Comment responses for #165, #170, #327, #347

David Ofelt - HPE
Gary Nicholl - Cisco
Eugene Opsasnick - Broadcom
Jeff Slavick - Broadcom
Kapil Shrikhande - Marvell
Mike Dudek - Marvell

PPM changes made from D2.1 to D2.2

Figure 176B-5— Examples of 200GBASE-R Physical layer implementations including the use of a 200GMII Extender for ppm rate matching

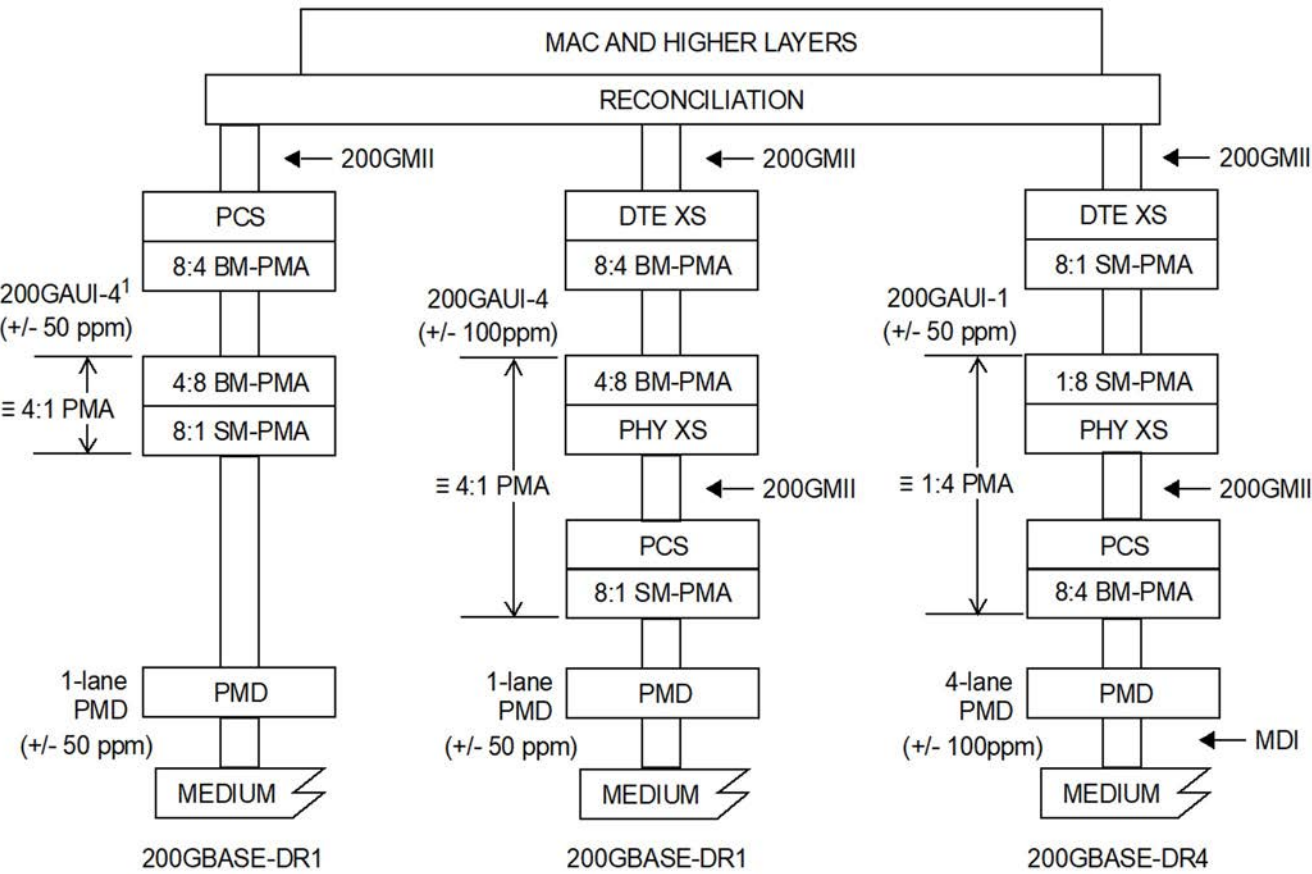
This sub-clause is "Special case for 200GBASE-R, 400GBASE-R, and 800GBASE-R PMAs" which discusses the bit-mux to symbol-mux conversion needed for 200GBASE-R and 400GBASE-R interfaces. There are actually two incompatible sets of 200GBASE-R and 400GBASE-R PMAs- one based on 100ppm signaling and the other on 50ppm signaling. The rest of the clause is accurate for the second (50ppm) group and shows that you just need a PMA-BM in addition to a PMA-SM to convert between the generations. For the first group (100ppm) there also needs to be a XS inserted in order to rate match between the different ppm domains. It would be useful to add some text to this part of 176B to indicate that the 100ppm interfaces need an XS - this would be similar to the text we added to 120.1.4

Add a new subclasse either under or after 176B.3 called "Special case for 200GBASE-R and 400GBASE-R using 100ppm signaling" with text indicating that an XS is required to rate match between ppm domains. Detailed suggestions for the text will come in a presentation.

Need a method to convert from lanes running with a signaling rate range of $\pm 100\text{ppm}$ to lanes running with a signaling rate range of $\pm 50\text{ppm}$ for 200GbE and 400GbE stackups containing sublayers with both.

For 200GBASE-R and 400GBASE-R Physical Layers, the signaling rate range for bit multiplexed lanes in some cases is specified as ± 100 ppm while symbol multiplexed lanes require ± 50 ppm. In these cases a xMII Extender (see Clause 118), with rate matching, is required to convert from a signaling rate range of ± 100 ppm to ± 50 ppm.

Examples of 200GBASE-R and 400GBASE-R Physical Layers with a mix of ± 100 ppm and ± 50 ppm signaling domains are shown in Figure 176B-5 and Figure 176B-6.

Add Figure 176B-5 to the new subclause 176B.3.1

¹ 200GAUI-4 where the signaling rate range is limited to +/- 50 ppm instead of +/- 100 ppm.
